Northeast
Utilities System

Re: Docket No. CSC 364 Waterford Substation - The Connecticut Light and Power Company
Application for a Certificate of Environmental Compatibility and Public Need for the
construction, maintenance, and operation of a proposed substation located off Oil Mill Road and
Waterford Parkway (North)

Response to CSC-01 Interrogatories dated 08/13/2008

Figure H-2 (Revised): Nearest Residences

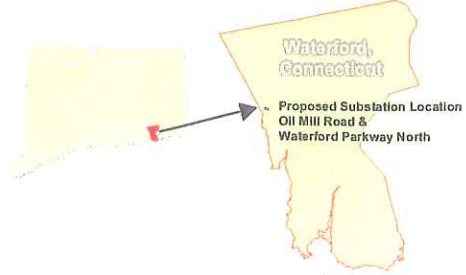
Question:
How many residences are located within 1,000 feet of the center of the proposed substation?

There is an error on figure H-2 of the application. CL&P inadvertently indicated a barn at a distance of 737 feet as a residence. Attached is the corrected figure, Figure H-2 (Revised).

Response:
Two (2).
